<b>Item</b>		<b>Page</b>
<b>4</b>	<b>958 VICTORIA ROAD, WEST RYDE. LOT 8 DP 819902. Local Development Application for alterations and additions to existing dwelling. LDA2012/47.</b>	
	Attachment 5 Previous report .....	1

**3 958 VICTORIA ROAD, WEST RYDE. LOT 8 DP 819902. Local Development Application for alterations and additions to existing dwelling. LDA2012/0047.**

**Report dated:** 24/09/2012 **File Number:** grp/12/5/5/3 - BP12/1089

The elevations of the proposal appear below:

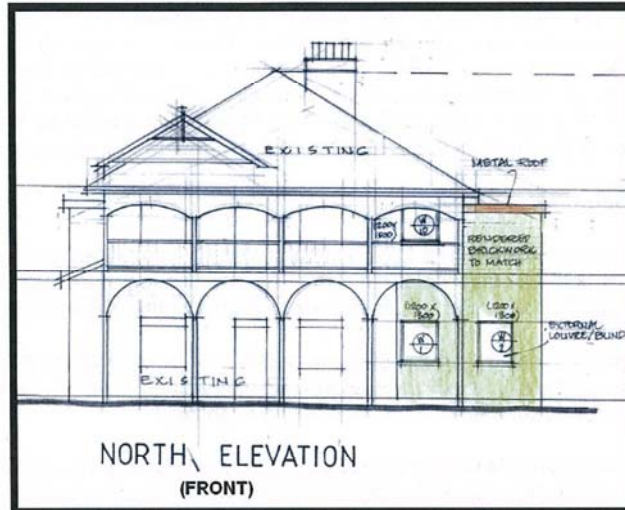
**1. Demolition of existing structures.** *Strong concerns are raised regarding the proposed demolition of structures on the western rear elevation – as these are integral to the building when it was first built as a single storey dwelling in c.1890. These should not be demolished but incorporated into the design of the proposed modern extension.*

**2. Skillion Roof.** *The proposed skillion roof is out of character with the original concept of the house. If a roof were to be designed as planned, consideration should be given to a hipped roof that is compatible with the pyramidal-styled roof of the two-storey building.*

**3. Window design.** *The windows of the proposed new extension would differ in style to those already present in the original front section of the house. The shape and configuration of the windows should render the proposed new extension compatible with the old.*

- 4. Modification of original fabric.** *The provision of 2 ensuite bathrooms (at ground and first floor) would significantly modify the fabric of the original building.*

Comment: These concerns are considered to be valid and are supported. They are discussed in more detail in the comments from Council's Heritage Officer (later in this report).

Comment: Agreed, these concerns have also been supported by Council's Heritage Officer as noted later in this report.

Comment: These concerns are also considered to be valid and are supported. These issues of concern could be resolved via submission of amended plans, however the design as currently presented is unacceptable.

Comment: Agreed, the 2 ensuite bathrooms would involve significant internal modifications to existing floors and ceilings to the detriment to the original building fabric.

**Figure 1:** Subject site with zone for development indicated by cross-hatching

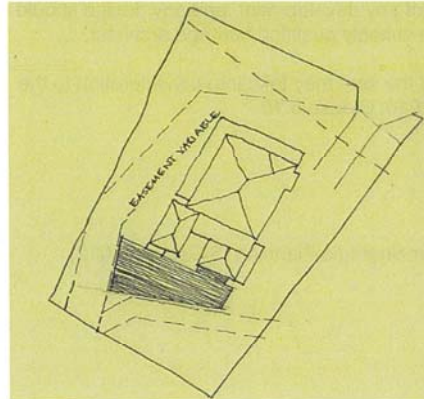
A desk top review of the survey plan was undertaken to determine the potential of an area on the subject site with the potential to support development. The review took into account the easements on the subject site and the required retention of the single storey rear wings. The below image identifies a 'zone' for potential development at the rear of the subject site identified by cross-hatching. The identified zone is to the rear of the existing rear wings and within an area defined by easements. It is recommended that the location of the easements is researched (in particular the "easement of variable width") and more accurately plotted in consultation with the relevant authorities.

A new rear addition may be constructed in the identified zone for development and attached to the existing building, but must include the following features:

- Material quality (wall and roofing materials) to be sympathetic to the existing heritage item
- Fenestration and external architectural detailing including the fire stairs to be designed to be sympathetic with the existing heritage item.

- Demolition of the existing unsympathetic rear stair will be favorably considered. To facilitate access to the second level of the dwelling, the wall closing off the existing internal stair at the ground floor could be opened up.

**Figure 2:** Indicative potential form and roofline of a rear addition, constructed within the identified zone for development

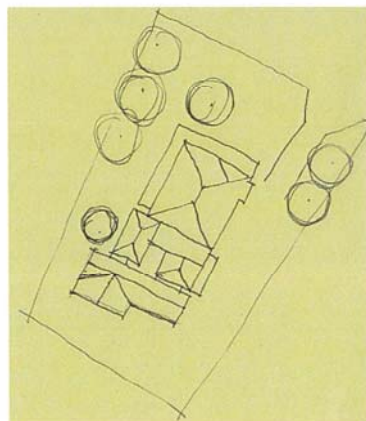
It is noted that Figure 2 is only indicative of any development, and any design should be carried out and works supervised by a suitably qualified heritage architect.
